## ICOMOS Technical Review

<b>Property</b>	<b>Bagrati Cathedral and Gelati Monastery</b>
<b>State Party</b>	<b>Georgia</b>
<b>Property ID</b>	<b>710</b>
<b>Date inscription</b>	<b>1994</b>
<b>Criteria</b>	<b>(iv)</b>
<b>Project</b>	<b>Proposal for reinforcing the base of the drum of the dome of Gelati monastery</b>

ICOMOS received a report on the *Project of the Arrangement of the Metal Belt on the Bottom Point of the Drum at the Church of the Virgin of Gelati Monastery*, submitted to the World Heritage Centre by the State Party on 20 July 2015.

**Figure 67.** The cupola : position of the established ring and additional reinforcing

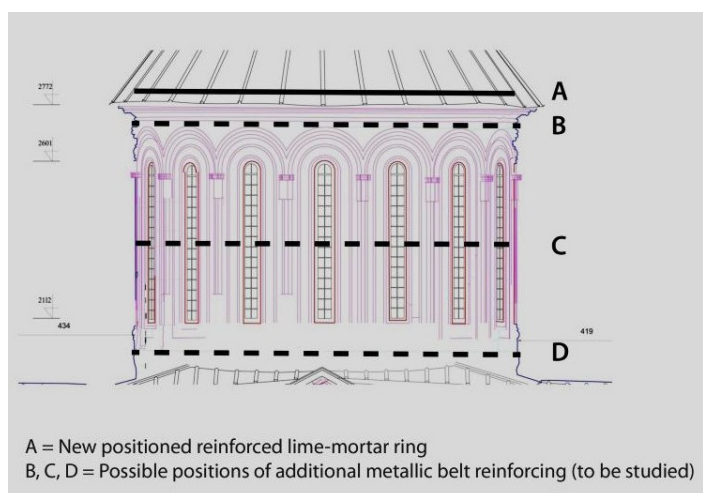
The **Report on the joint ICOMOS / World Bank advisory mission, 21-25 January 2015** (hereafter – **Report**), raises the question whether the drum of the dome could withstand potential strong horizontal seismic pressure, given the following facts: the great height of the drum, the large number of openings (windows) that perforate the body of the drum, and the narrow trunk of the intermediate walls-piers (see Report: pages 32 and 41-par.5.3.2 and compare figs. 67-C, 68 and 18).

**C.** The already installed reinforced ring-beam at the base of the hemisphere (place A of Figure 67) and the additional proposed metallic belt at the base of the drum (place D of Figure 67) will undoubtedly enhance the static stiffness of the drum at its upper and lower ends. Regardless of these interventions, the behavior of the body of the drum (place C of Figure 67) remains problematic in the case of a future strong seismic act. After this, the most weakened parts of the drum remain the elongated “free-standing” masonry piers. This is proved by the “Structural Analysis” of the **“Proposal for reinforcing the base of the drum of the dome”**: displacement along the axes X and Y (plans F1X and F1Y in all three versions I-II-III), where the cupola is more vulnerable to the directions E → W and S → N instead of W → E and N → S because of the already walled windows of the drum.

**Figure 79.** Proposed jacks for pre-stressing the dome

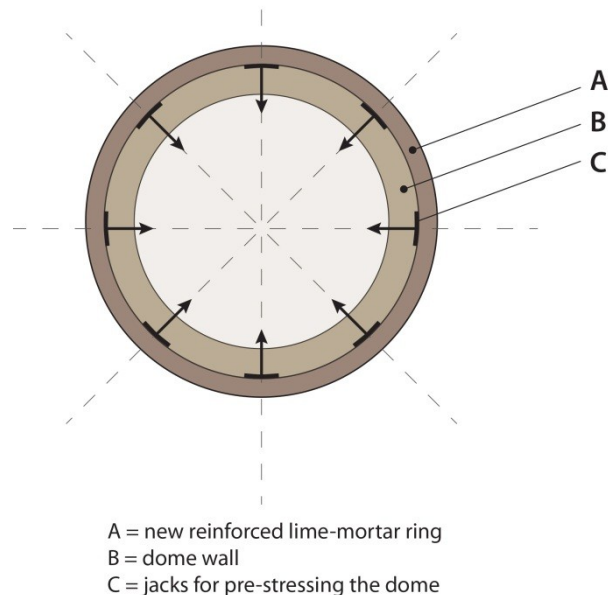
**A.** In order to ensure better adhesion between the metallic ring and the stone construction of the dome, it is proposed to introduce a filling in the space between the two mating surfaces. On the issue of this kind of collaboration between the two materials, in the **Report** it was recommended that “... if necessary, the ring-beam’s contribution can be improved by inserting, between the ring-beam and the base of the dome, a system of jacks able to produce supplementary horizontal radial inward forces (fig.79, fig.80, fig.81), pre-stressing, by this way, the dome ...” (Report page 41, par. 5.3.1). The system of jacks can ensure satisfactory adhesion between the ring-beam and the cupola construction, and therefore a constant and controlled cooperation between them in a more “flexible” way, which additionally could “undertake” future tensions resulting negatively to further opening of the cracks.

**Figure 14.** Schematic proposal for supporting the drum of the dome, consisting of metal rings and metal frames on the windows, while covered by full length metal sills

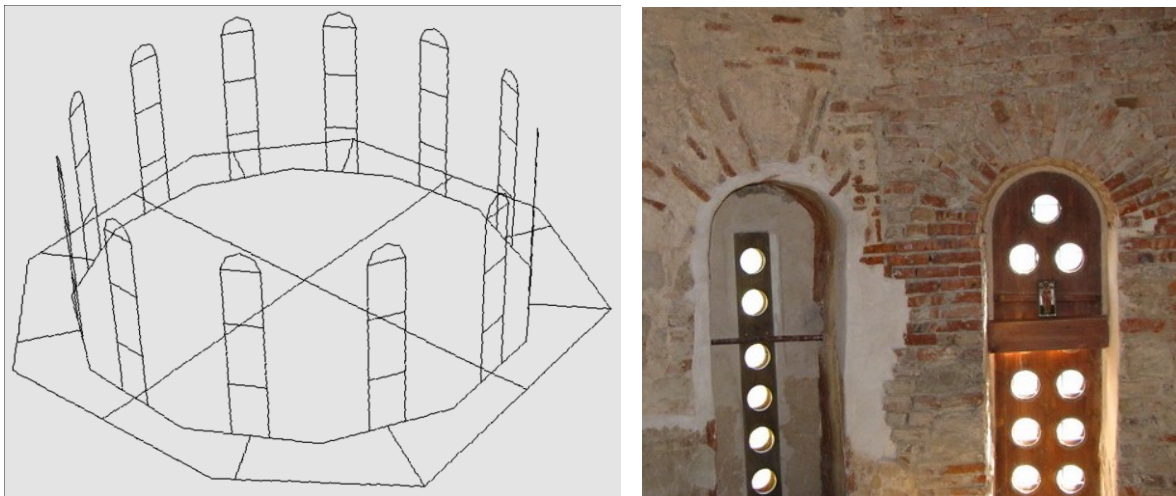
In such a case, for further improvement of the stability of the drum, it would be advisable to consider the idea of setting up specially-designed steel elements in the form of full length metallic windows, with strong steel frames, connected between them, in order to “close” the window openings, leaving small round intermediate openings for lighting the dome: this would be in practice an imitation of medieval full-length wooden windows. Such a construction requires additional calculations, taking into account the possible thickness of the metallic windows and the dimensions of the steel frames.
